## BERNINA Firmware Release B 880 – V351043

Steckborn, 20.05.2015

### Information on Firmware Update

#### - Embroidery function “Endless embroidery”

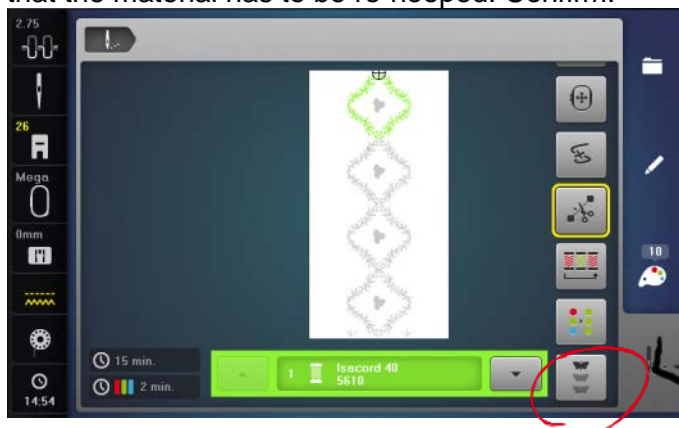
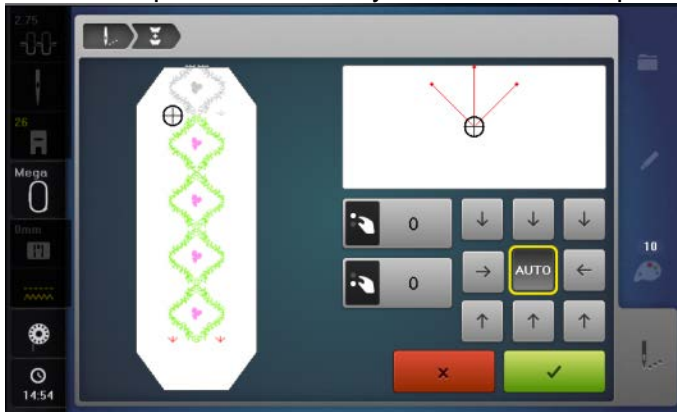
The function “Endless embroidery” can now also be selected in the embroidery mode and allows a continued embroidering of already started borders, even if the machine has been switched off and on again. This improvement enables the user to interrupt border projects (when the machine is switched off) and to restart at the same point (the machine is switched on again).

- 1) Create a border featuring a reference motif. Embroider and complete the reference motif. Save it afterwards and switch the machine off.

- 2) Switch the machine on again, open the embroidery motif in your personal memory and change to the embroidery mode. Select “Endless embroidery” and an animation indicates that the material has to be re-hooped. Confirm.

- 3) The embroidery hoop is moved near the last stitch. Via the multifunction knobs the horizontal and the vertical position of the needle in the embroidery hoop can be adjusted so that it is positioned exactly over a reference point.

- 4) Now the border embroidery can be resumed at the correct position.
